VCS JOINT VALIDATION & VERIFICATION REPORT FOR

ANHUI ZHUJIXI CMM UTILIZATION PROJECT

Report ID	0104020323034(001)
Project Title	Anhui Zhujixi CMM Utilization Project
Project ID	4559
Verification period	14/12/2021 to 31/07/2023
Crediting period	14/12/2021 to 13/12/2031
Original date of issue	27/11/2023
Most recent date of issue	11/11/2024

Figure 3.1-1 Technical flow chart of the project activity

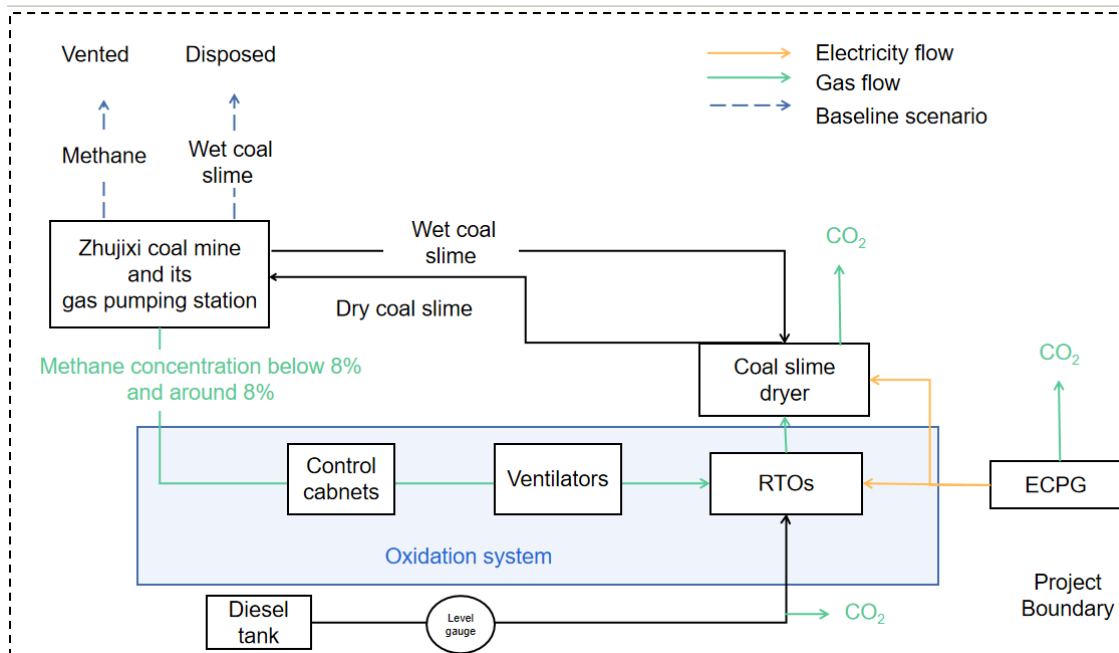
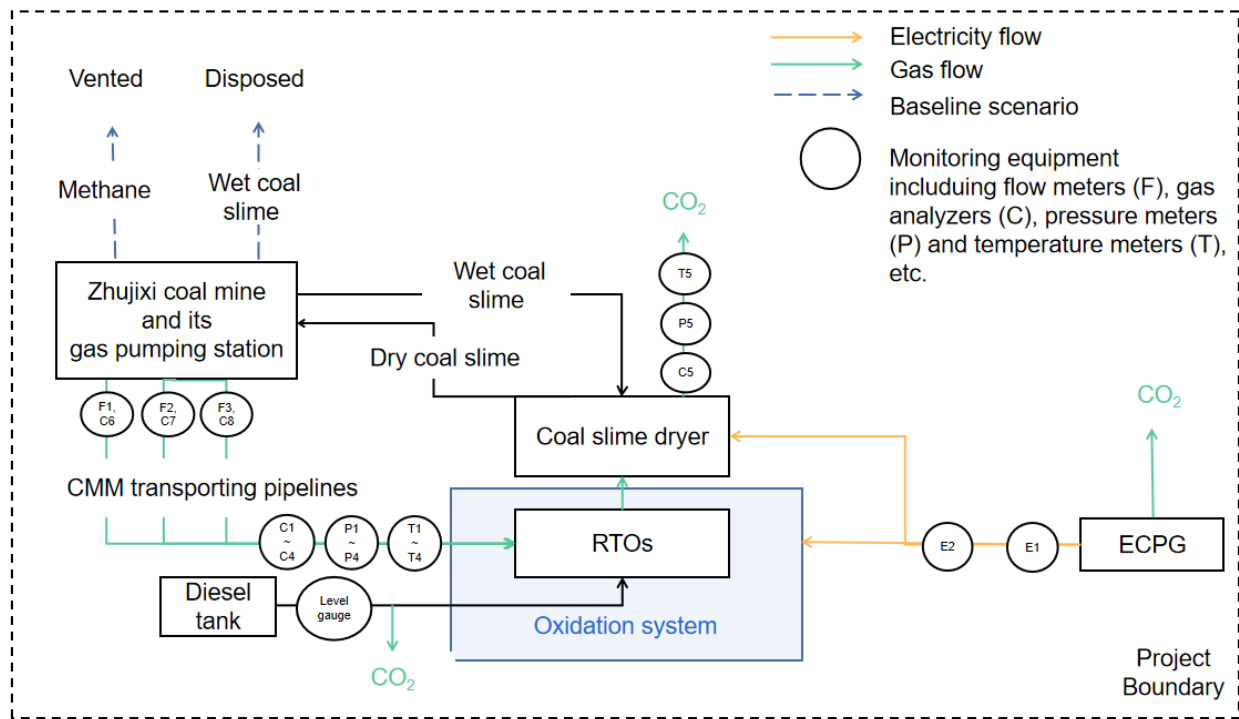
CAR-8 The technical flow chart/diagram of monitoring system shall include the monitoring points of inlet and outlet of the RTOs.	The technical flow and project boundary is repainted. The monitoring plan is repainted, too. Monitoring equipment is presented properly.	The revised PD & MR was checked and it has been confirmed that technical flow chart/diagram of monitoring system includes the monitoring points of inlet and outlet of the RTOs. This CAR is closed.
CAR-9 The values of the parameter $Eff_{ox,y}$ is calculated incorrectly in the emission reductions calculation spreadsheet.	ER sheet is recalculated and corrected.	The emission reductions calculation spreadsheet has been checked and it has been confirmed that values of the parameter $Eff_{ox,y}$ is corrected. This CAR is closed.
